Enclosure 2

VPN-021-99

**Independent Spent Fuel Storage Installation
Technical Specification Update**

**Summary and Description of Changes
to Trojan ISFSI Technical Specifications**

FIGURE 4-1

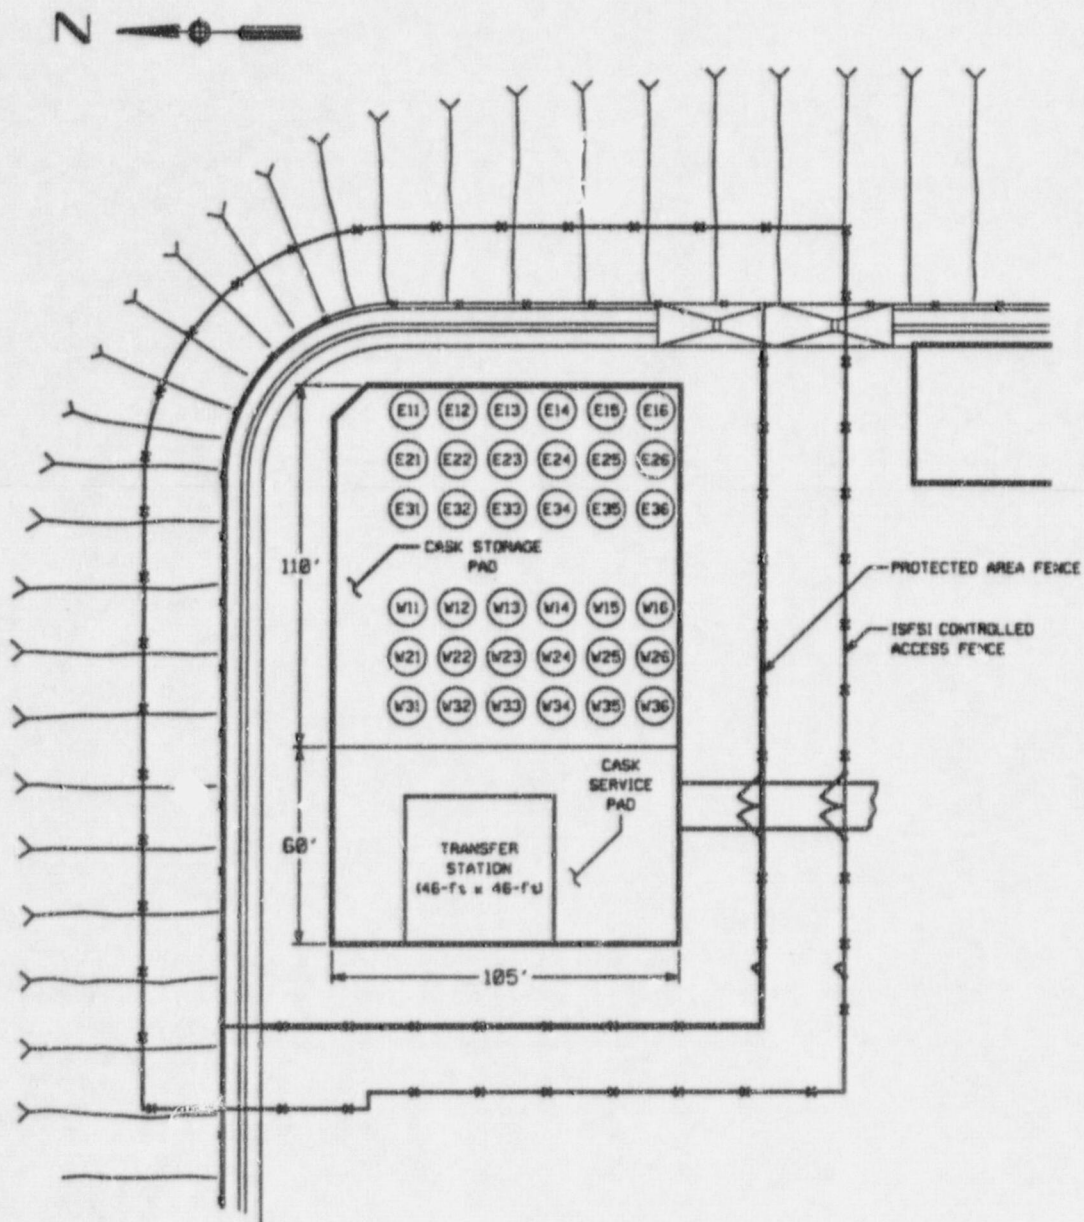
11	4.0-7	Table 4-2	Added new table listing the CONCRETE CASK Code Deviations.
12	4.0-8	Figure 4-1	Repagination because of addition of new table listing CONCRETE CASK design standard deviations.
13	B3.4-1 to B3.4-3	BASES	Added new Bases for the AIR PADS.
